ND-09-1190

Southern Nuclear Operating Company  
Vogtle Electric Generating Plant Units 3 and 4 Combined License Application  
Supplemental Response to Request for Additional Information Number 02.04.02-1

**Supplemental Response to NRC RAI Number 02.04.02-1**

Figure 2.4-201a  
 Cross-Section Location Map for HEC-RAS Model of Local PMF for Units 3 and 4

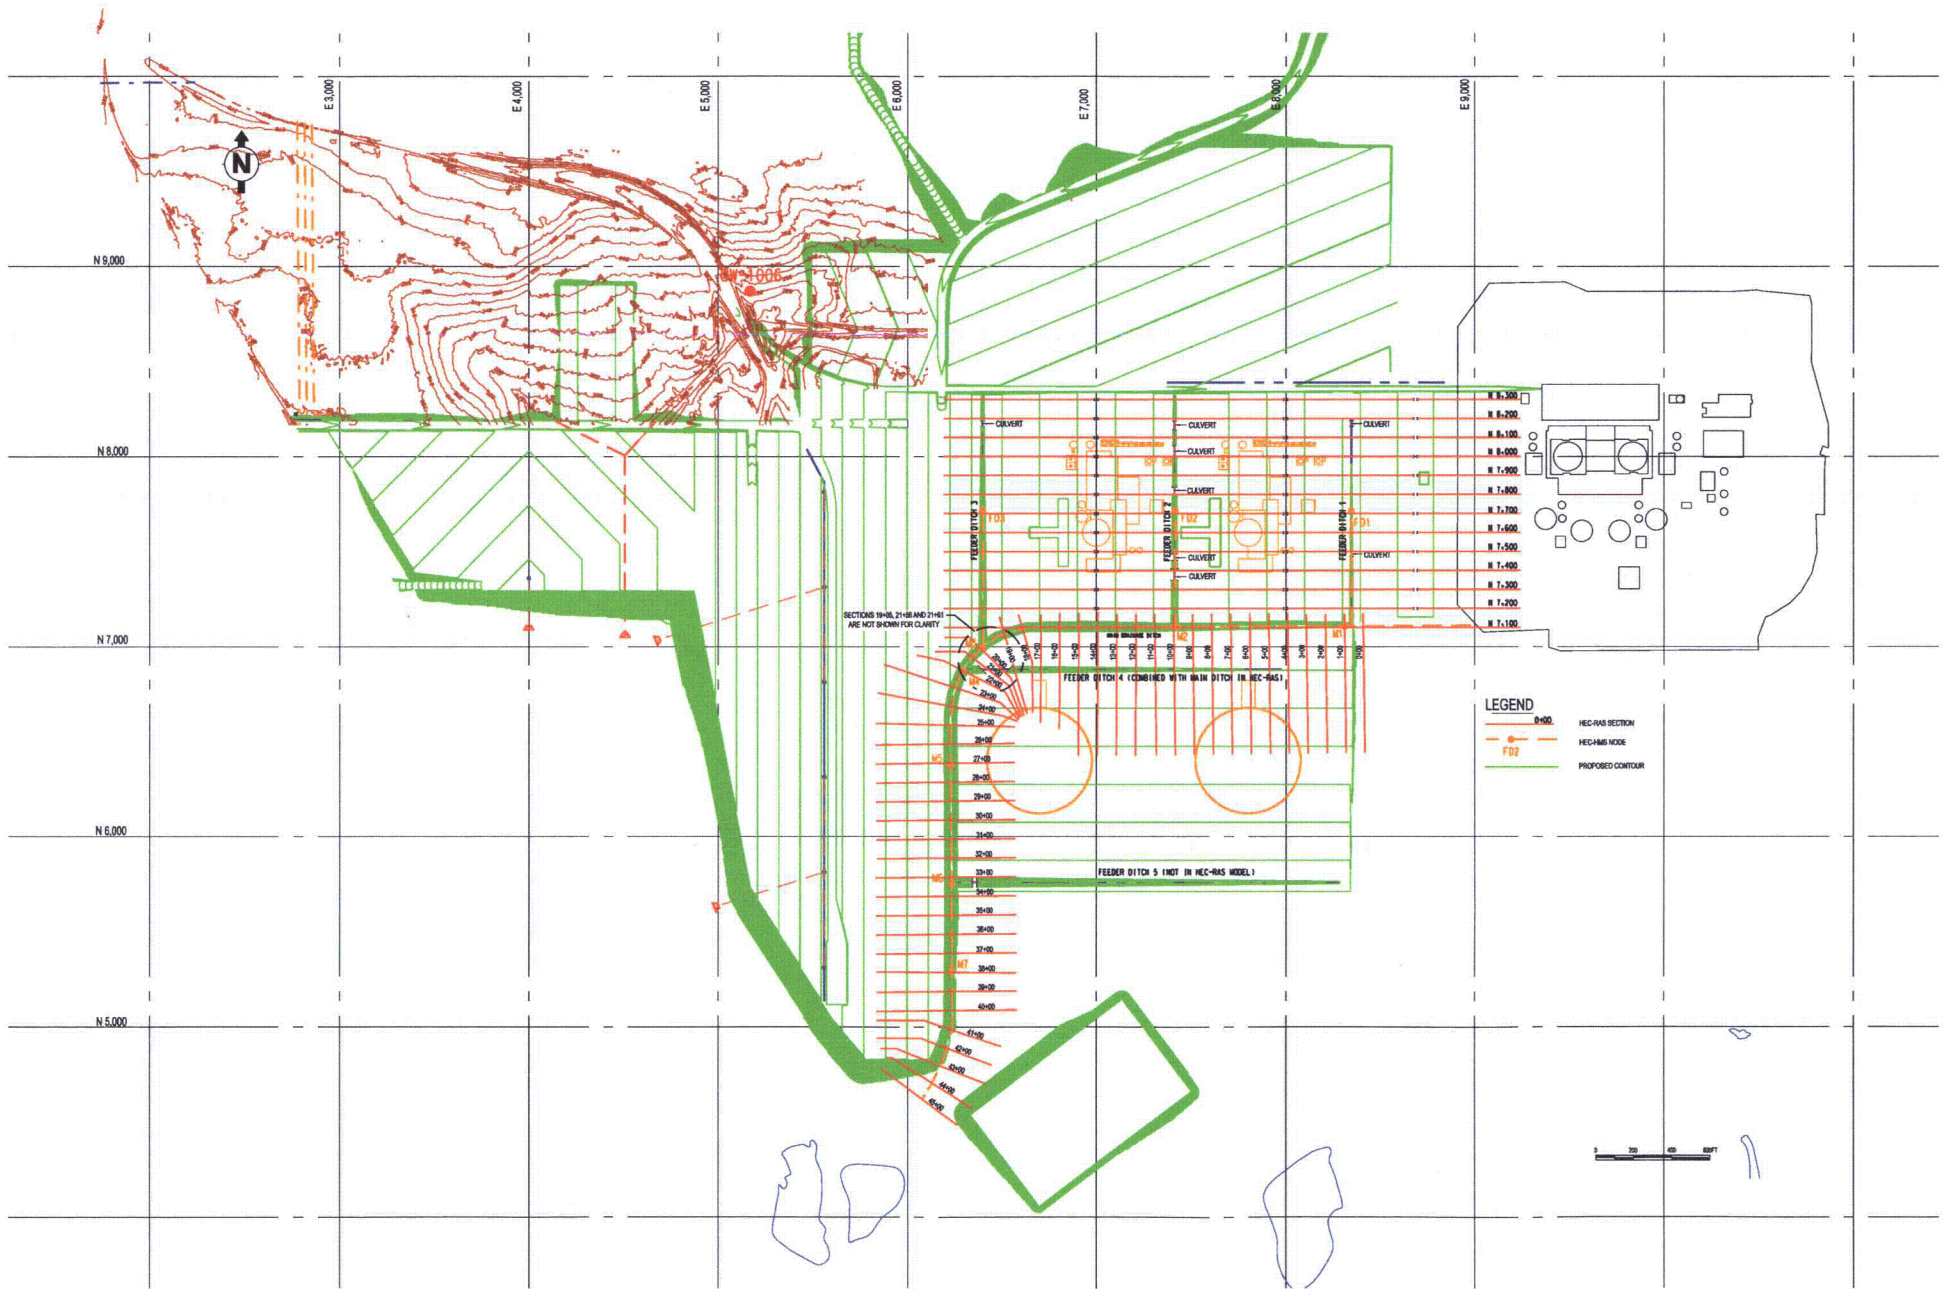
In a telephone conference to discuss the SNC response to NRC RAI Number 02.04.02-1 on April 21, 2009, the NRC noted that the culvert at the downstream end of Feeder Ditch 4 was not included in the hydraulic model. SNC responded that the changes to the probable maximum precipitation (PMP) flood water surface elevation within the power block area would be minimal, since the culvert would be located in the backwater of the main ditch, resulting in low velocities and head loss. However, SNC agreed to an NRC request to reevaluate the maximum water surface elevation with the blocked culvert included in the model.

In a follow-up telephone conference on May 8, 2009, SNC reported that preliminary revision of the cross-section geometry in the hydraulic model to include the culvert in question had resulted in a small increase in the maximum water surface elevation, as anticipated – i.e., 0.02 feet (from 219.45 to 219.47 feet). The NRC also noted a bottom width variation in a cross section in the main channel and requested that this section (and any others as necessary) be adjusted and included in a revised hydraulic model of the PMP drainage system. The NRC further requested a copy of the revised hydraulic model input files for their evaluation and reference.

This supplemental response to RAI Number 02.04.02-1 provides the results of the revised HEC-RAS model for local PMP flood level analysis of the VEGP Units 3 and 4 power block area. FSAR changes reflecting results from this updated hydraulic model are provided below for FSAR Subsections 2.4.2.3 and 2.4.10, Tables 2.0-201 and 2.4-207, and Figure 2.4-201a. Additionally, revised model input files are provided on compact disc (CD) in Enclosure 3.

- All channels are concrete lined, so no local scoured-out cross sections are utilized in the model.
- All culverts in the model are assumed to be 100% blocked by debris collected from the catchment.
- The blocked culverts within the power block area are modeled as in-line weirs in HEC-RAS following common hydraulic engineering practice (Reference 205). The effect of the blocked

culvert in Feeder Ditch 4 is accounted for by adjusting cross section geometry to indicate the ditch is filled in at the culvert location.

5. COL Application Part 2, FSAR Figure 2.4-201a will be revised as shown in Enclosure 2.
